UNITED STATES PATENT AND TRADEMARK OFFICE

Office Action Summary

10/522,241

DETAILED ACTION

FIG. 34C

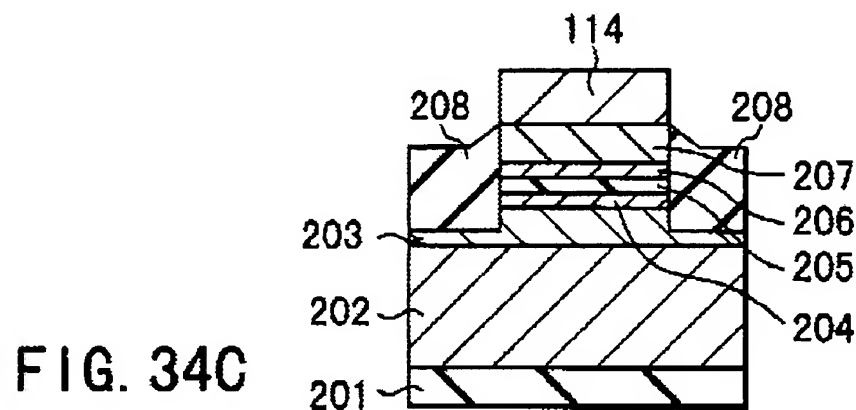
17. Per **Claim 71** Noguchi (e.g. figure 34A-34C) discloses a device, comprising

- a spin injector ((203), (204), and (205)) for injecting spin-polarized hot carriers by a spin-filter effect;
- a spin analyzer ((205), (206), and (207)) for selecting the thus injected spin-polarized hot carriers by the spin-filter effect.

19. Per **Claim 72** Noguchi discloses the device of claim 71 including where the spin injector ((203), (204), and (205)) comprises

- a first ferromagnetic barrier layer (204) through which the carriers can be transported by tunneling upon application of a voltage across said first ferromagnetic barrier layer;
- a first nonmagnetic electrode layer (203) joined to one end surface of said first ferromagnetic barrier layer; and
- a second nonmagnetic electrode layer (205) joined to the other end surface of said first ferromagnetic barrier layer.

20. Per **Claim 73** Noguchi discloses the device of claim 71 including where spin analyzer ((205), (206), and (207)) comprises

- a second ferromagnetic barrier layer; (206)
- a second nonmagnetic electrode layer (205) joined to one end surface of said second ferromagnetic barrier layer; and
- a third nonmagnetic electrode layer (207) joined to the other end surface of said second ferromagnetic barrier layer,
- wherein said second nonmagnetic electrode layer (205) is common to said spin injector and said spin analyzer.

25. Per **Claim 82** Noguchi discloses the device of claim 81 including where said second nonmagnetic electrode layer (205) of said transistor is connected to a wordline (202) , said third nonmagnetic electrode layer (207) of said transistor is connected to a bitline (114), said bitline is connected to a power supply via a load, and said first nonmagnetic electrode layer of said transistor is connected to ground (column 25 lines 41-59).
